Road & Bridge Design Publications

Monthly Update – June 2012

Revisions for the month of **June** are listed and displayed below. New special details are to be included in projects submitted for the **September** letting as is stated on the special detail index sheets. Please contact Wayne Pikka (pikkaw@michigan.gov) for any questions related to the road changes or Vladimir Zokvic (zokvicv@michigan.gov) for questions related to the bridge changes.

STEEL END SECTION FOR 4" OR 6" PIPE

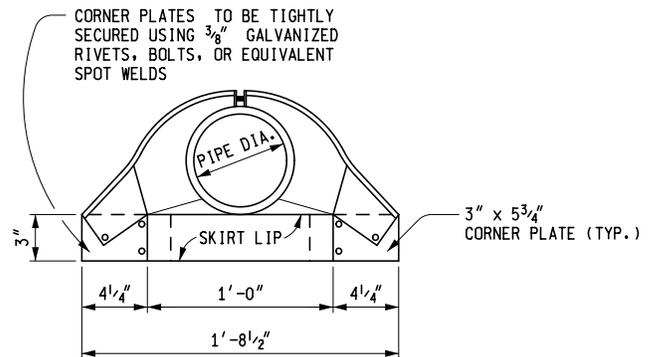
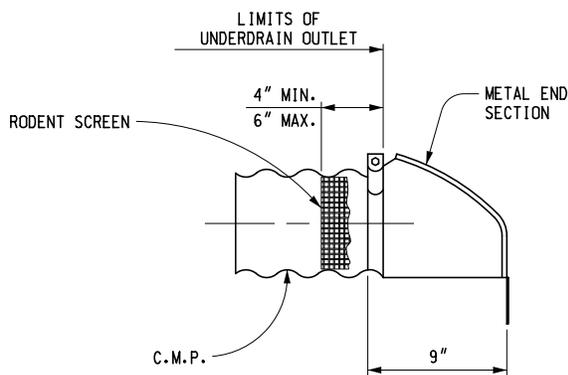
R-80-E: Granular Blankets, Under Drains & Outlet Endings, & Sewer Bulkheads: In the note section, a note was added which allows steel end sections to be attached to the ends of PVC outlet pipe.

STEEL END SECTIONS MAY ALSO BE ATTACHED TO THE ENDS OF PVC OUTLET PIPE AS APPROVED BY THE ENGINEER BY USING A PVC ADAPTER THAT PROVIDES SIMILAR RESISTANCE TO MOVEMENT OF THE CONNECTION DEVICE AS THAT PROVIDED BY STEEL PIPE CORRUGATIONS. DIRECT ATTACHMENT OF THE STEEL END SECTION TO END OF STANDARD PVC OUTLET PIPE IS NOT ACCEPTABLE.

SECTION A-A

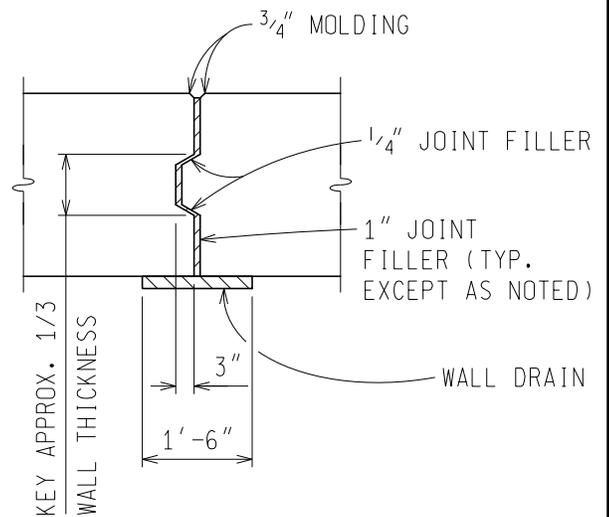
5.20.02: Rotated section A-A view to correspond to section lines in wall elevation.

8.11.06

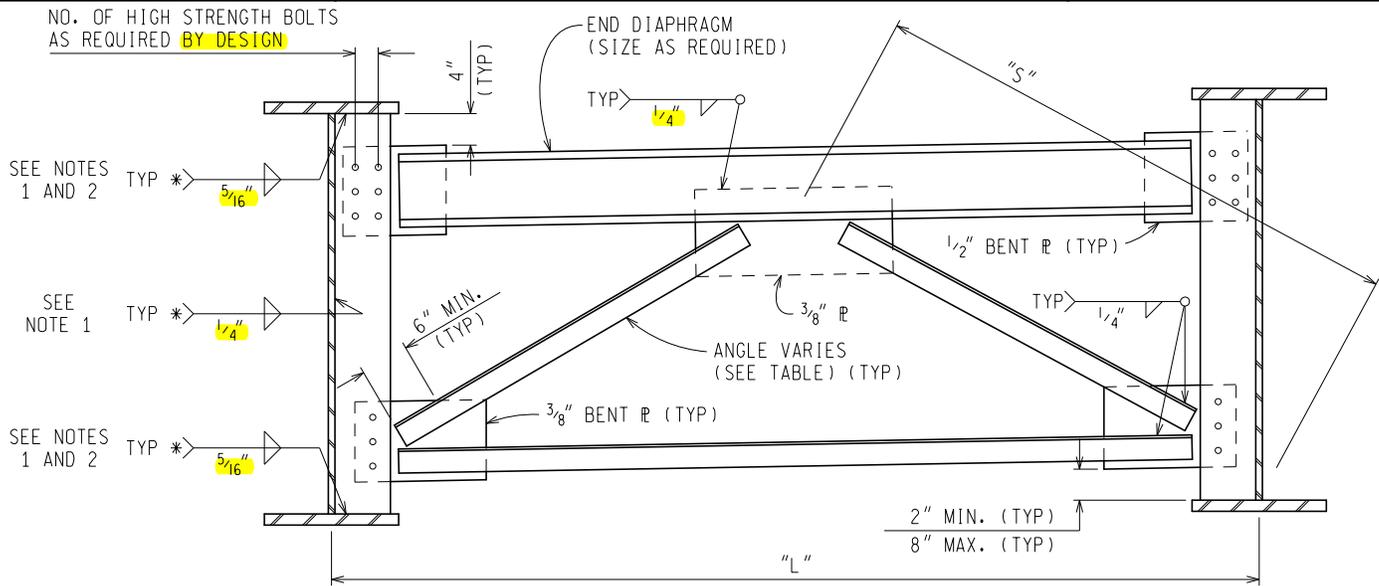
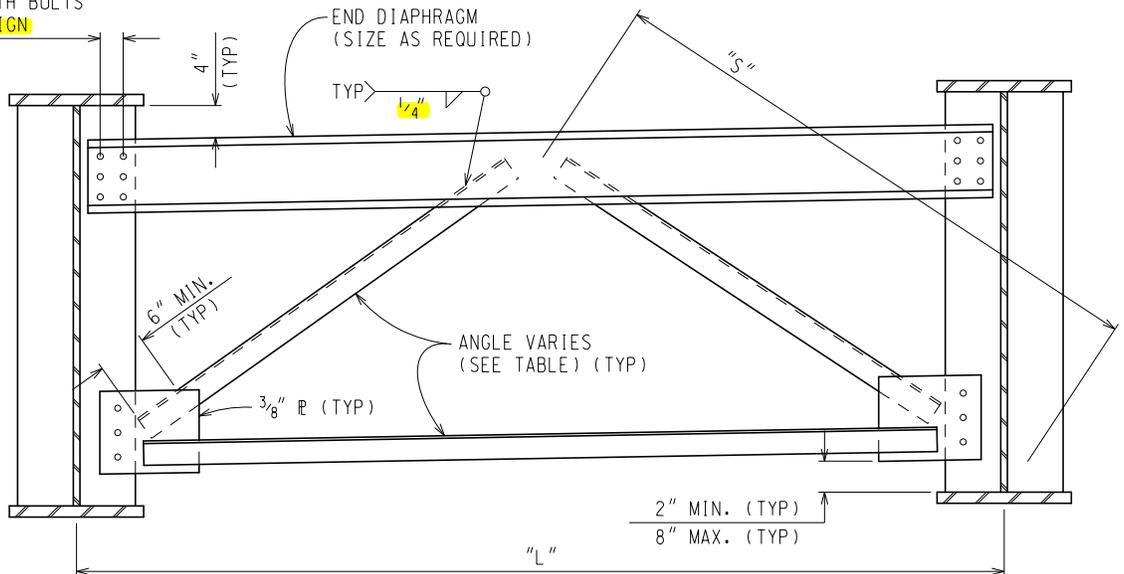
8.11.06, 8.11.07, 8.15.01, 8.21.03: Updated welding symbols. None of the intended welds changed just the way they are presented on the details.
